# ARCHITECT'S SUPPLEMENTAL INSTRUCTIONS

Date Issued:	May 29, 2020
Project:	Intermountain Healthcare <b>Tooele Valley Dialysis Clinic Expansion</b> 2356 North 400 East, Suite #102 Tooele, Utah 84074
Architect's Supplemental Instructions:	<b>ASI #8</b>
To:	Saunders Construction 1113 South 500 West Bountiful, Utah 84010

**RE:** ASI-008 – Domestic Piping to Sinks -Ref RFI-004

**A113**

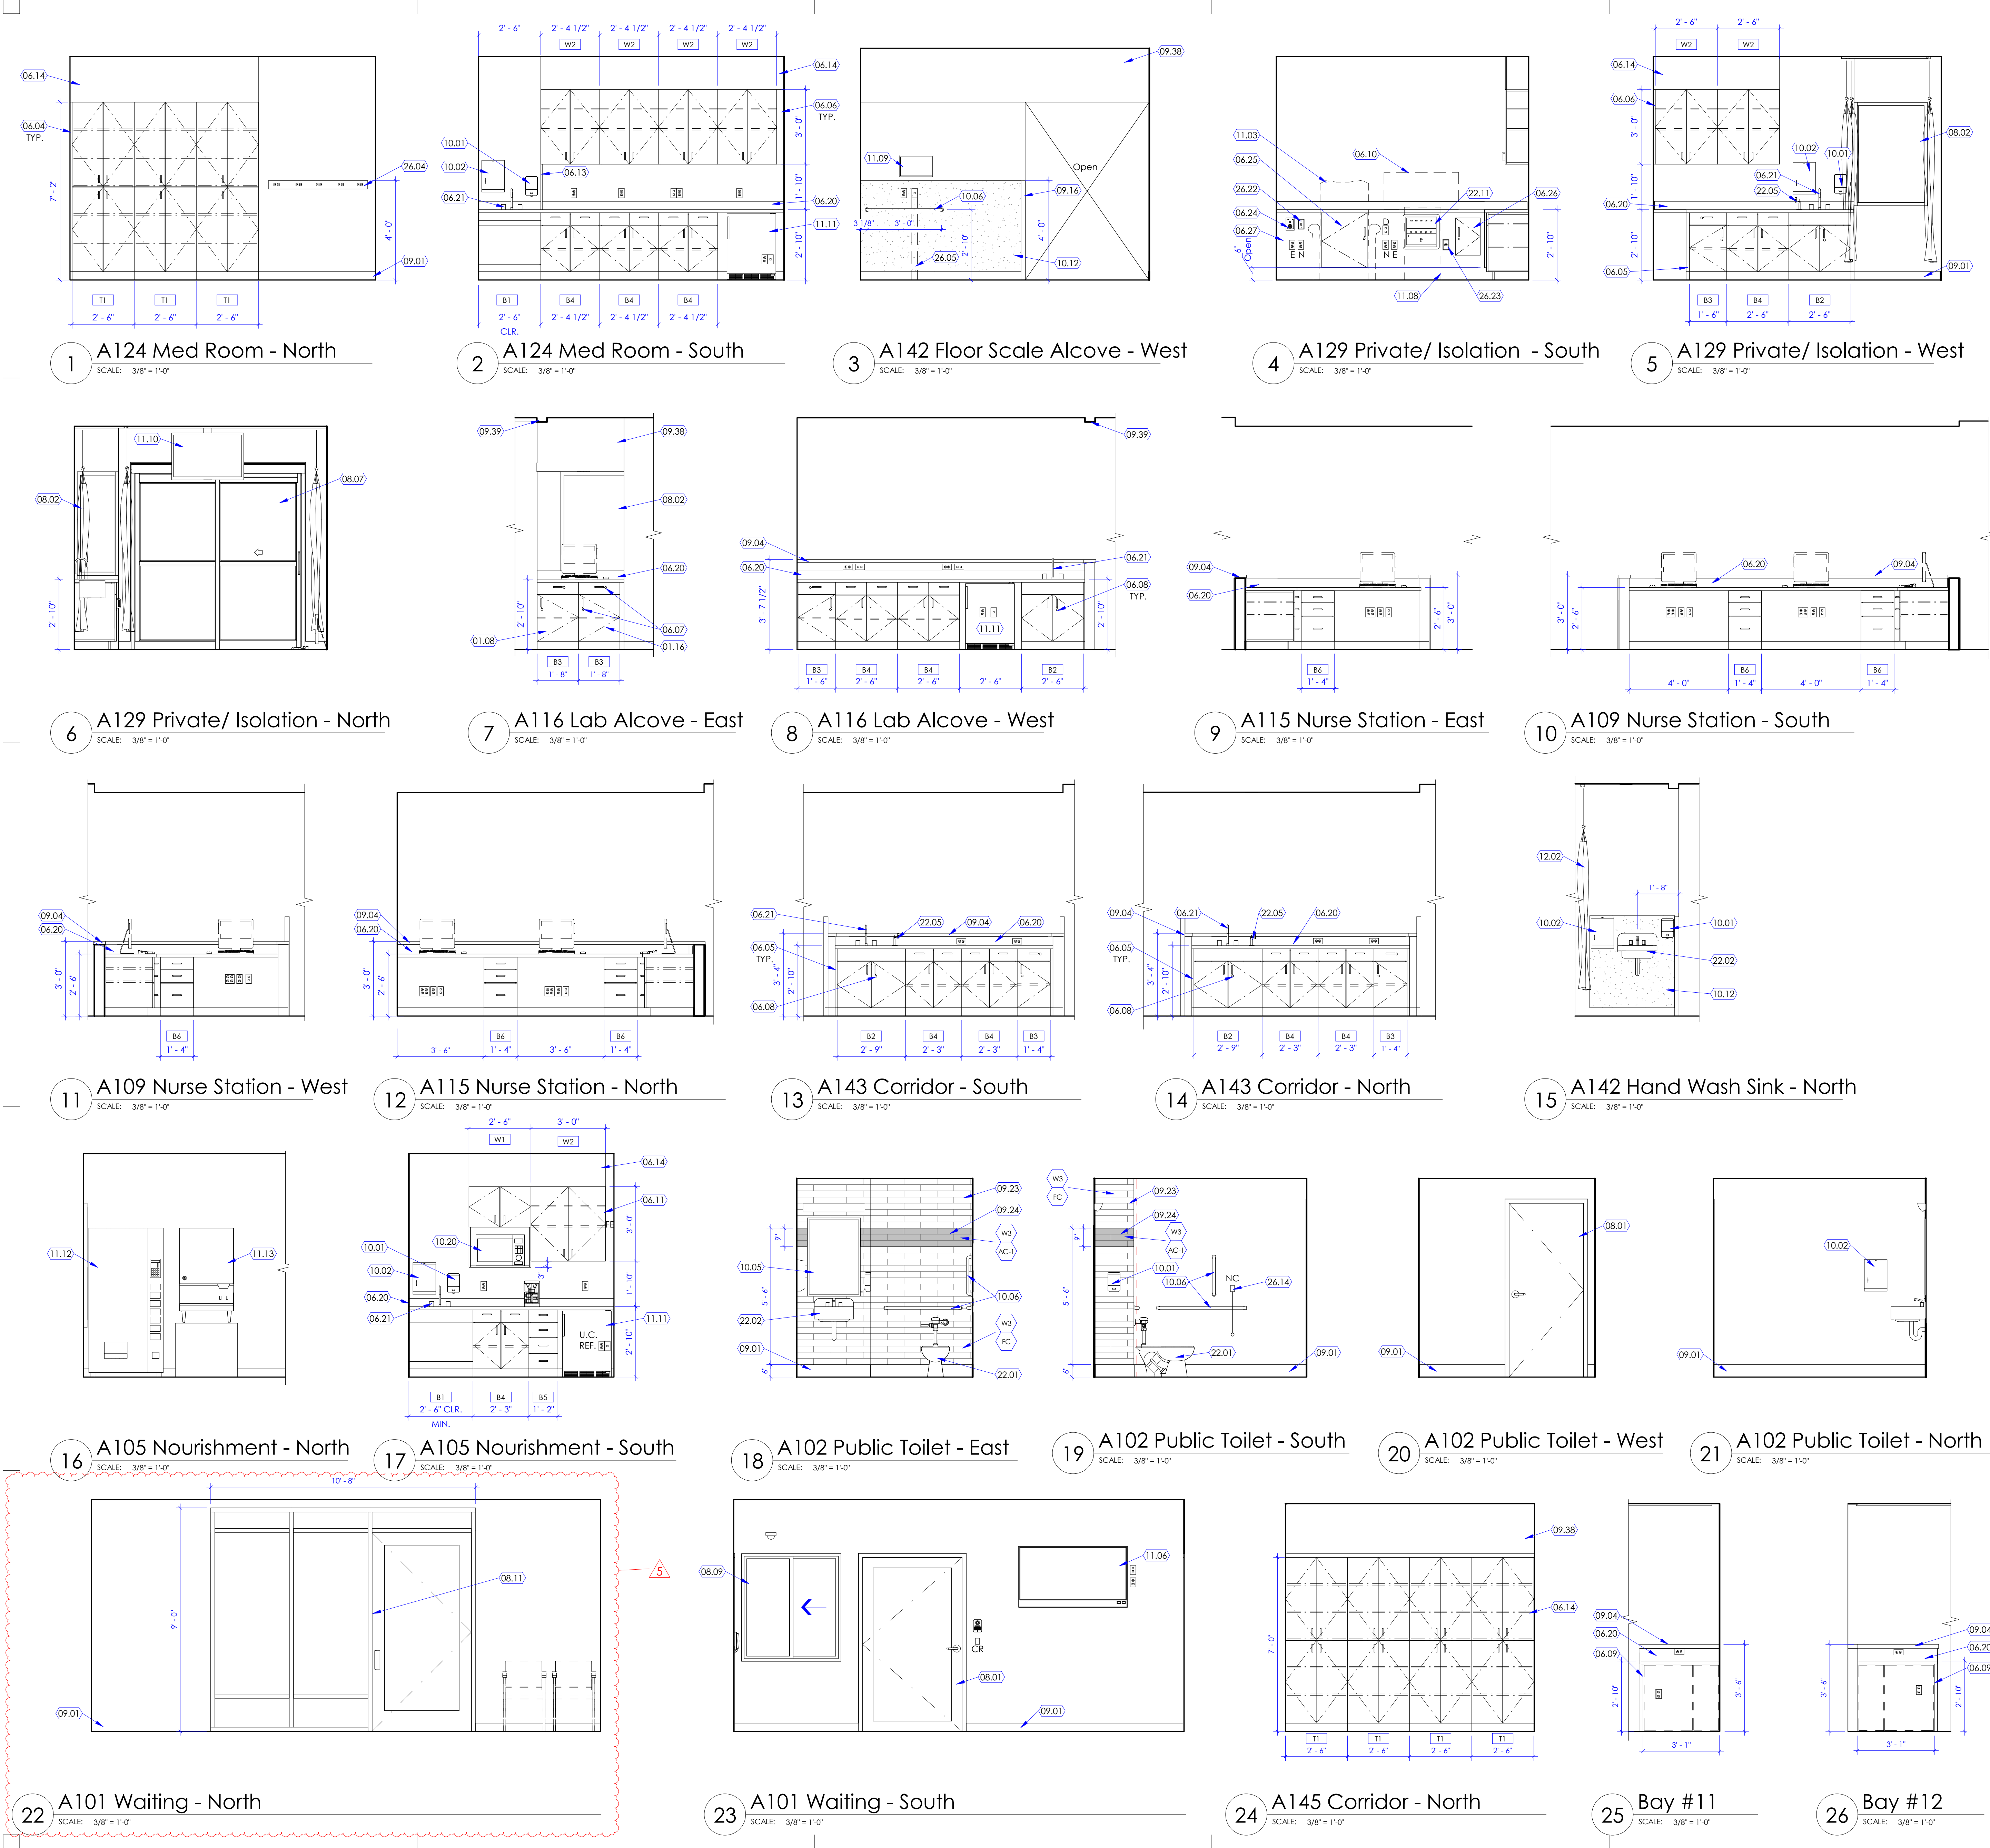
Item Number	Description
1	As requested by the Owner main entrance door window system A101A & W1 to the dialysis suite has been revised to match the storefront system at the main building hallway in appearance and color. Field verify adjacent existing to match. This will be a 45-minute fire rated glazed Hollow metal door window system as indicated in the attached revised sheets. As an alternate- also provide price to fabricate this glazed door window system in 45-minute fire rated Aluminum storefront system. See attached revised sheets with revisions shown clouded for more information.
2	See attached Plumbing ASI #8 from VBFA Engineers prepared in response to RFI #04 to revise piping at three island sinks. See attached revised plumbing sheets PP100 & PP101 with revisions shown clouded for more information.

**PP100**

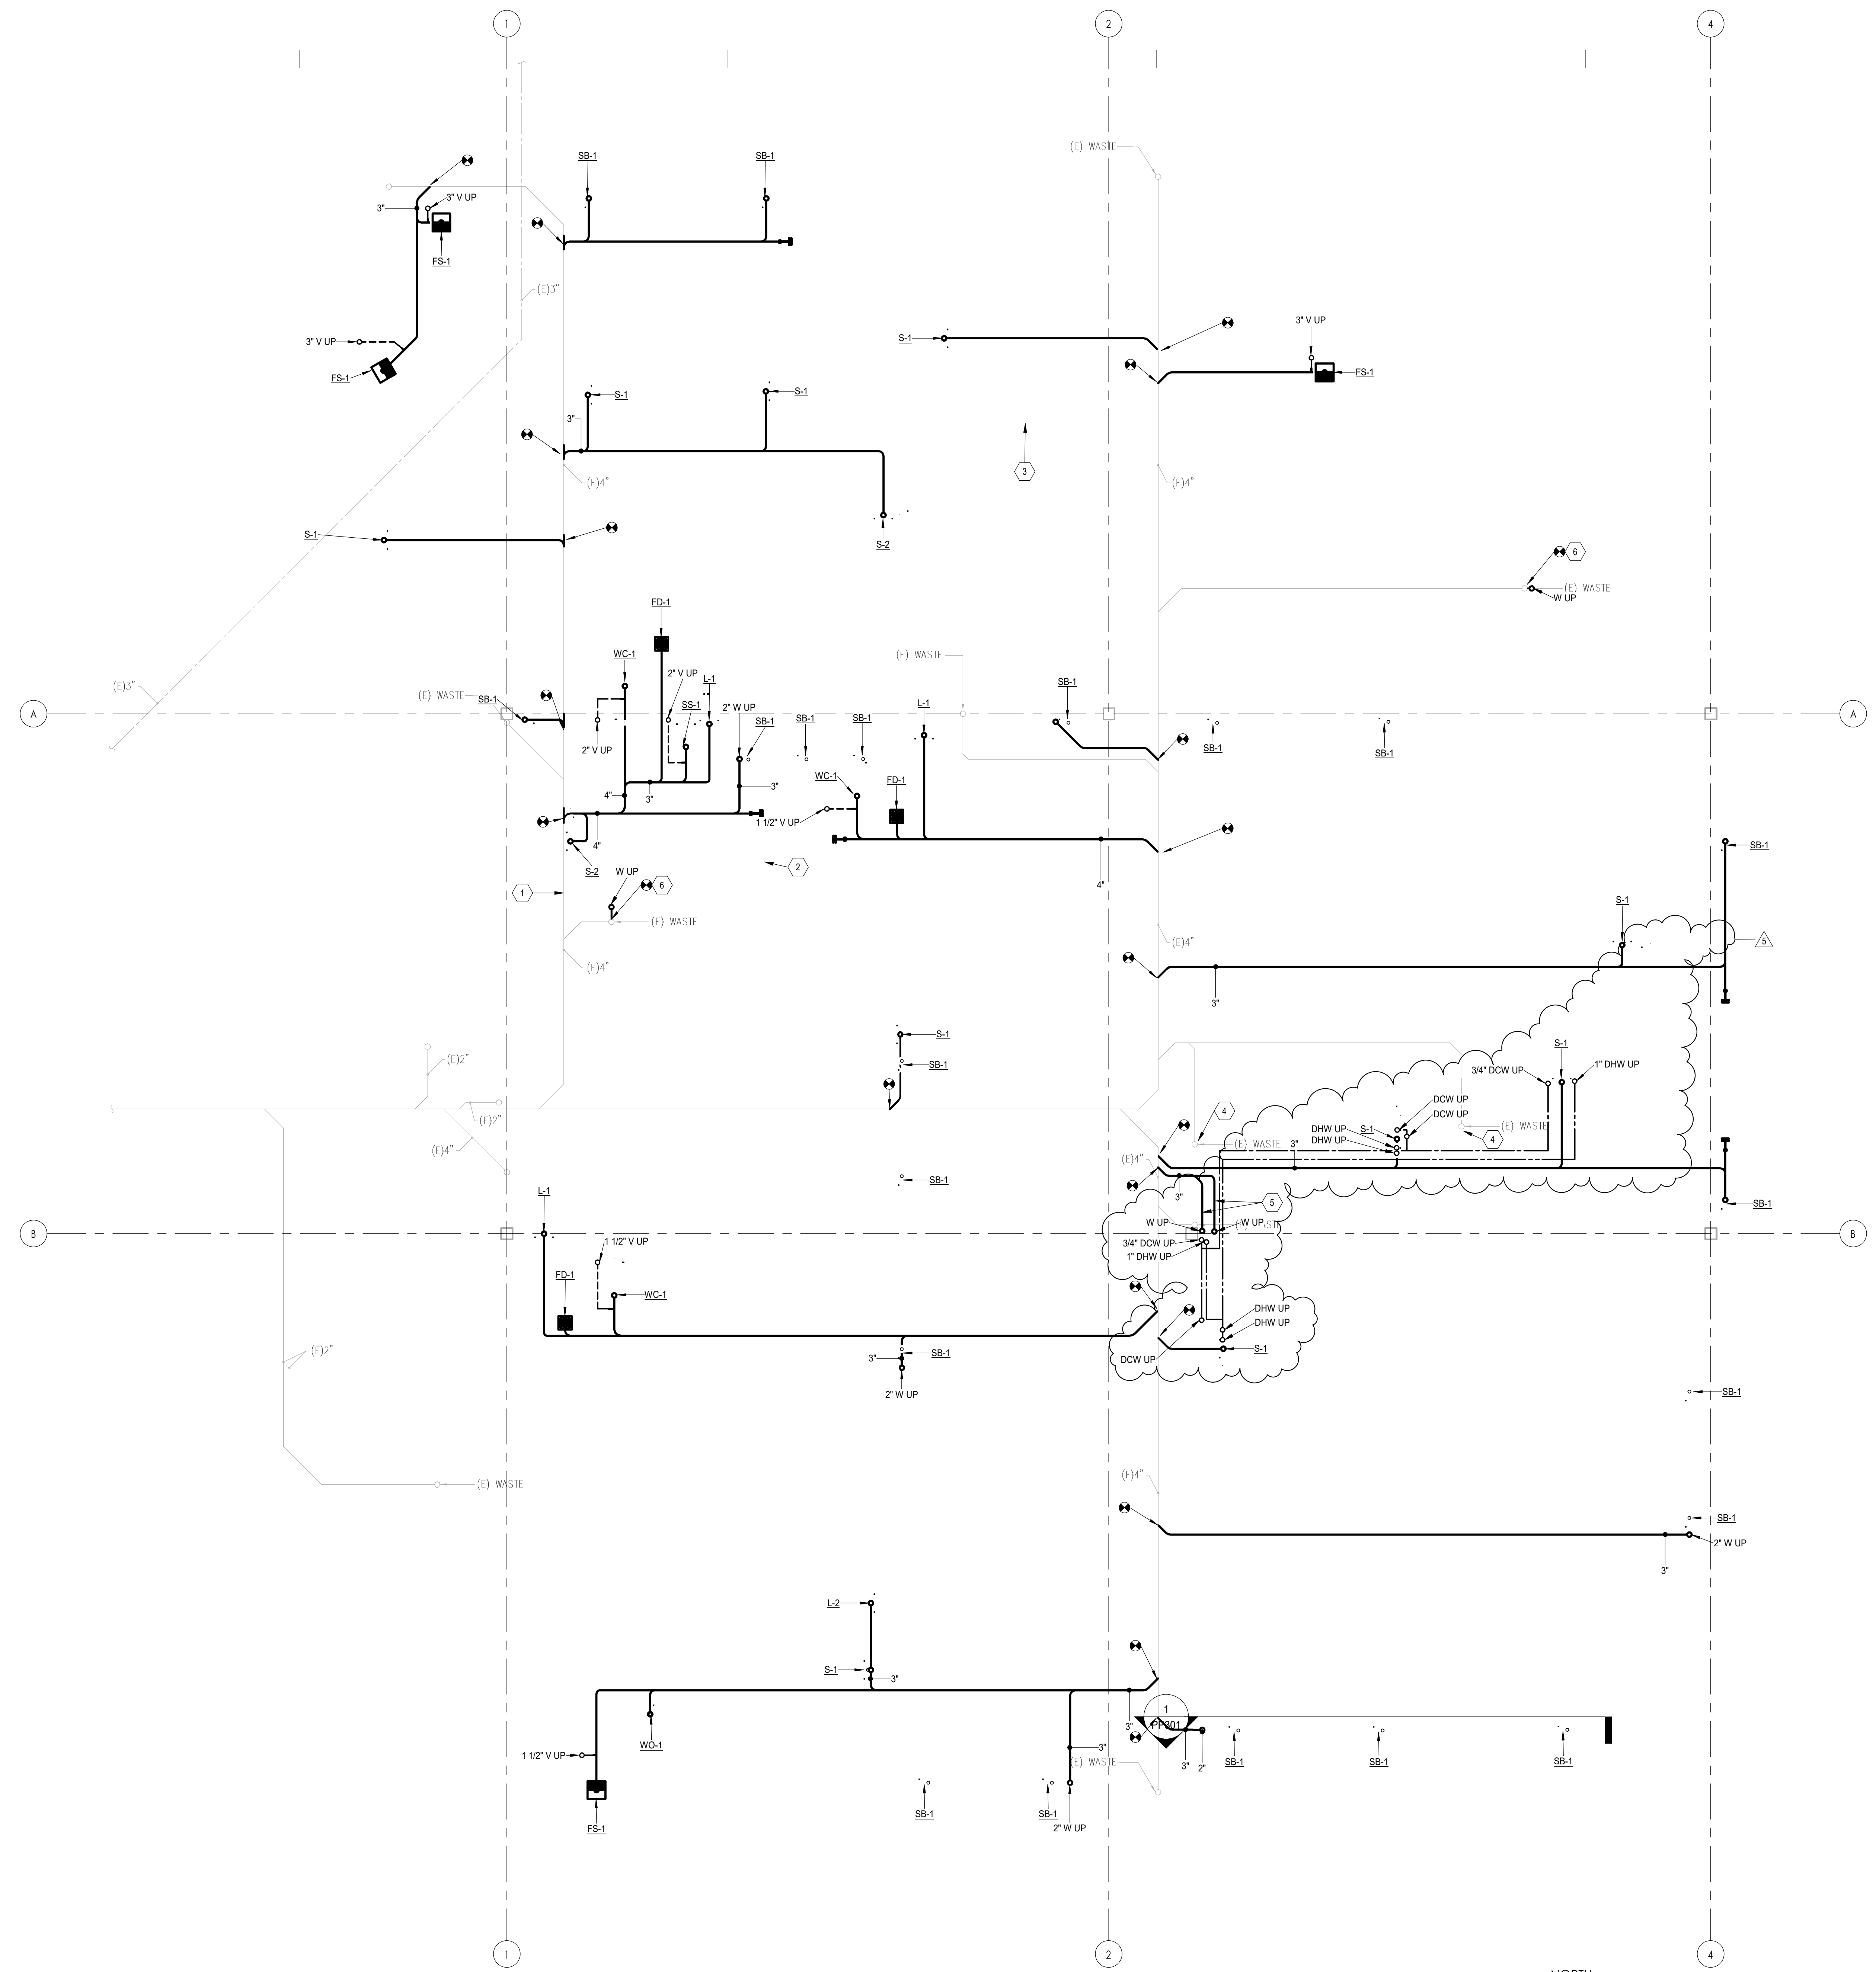
- 1" DHW main dropped to go below grade to run to sinks in the following locations: Room A116, Room A122, and Corridor A145.
- 3/4" DCW branch dropped to go below grade to run to sinks in the following locations: Room A116, Room A122, and Corridor A145.
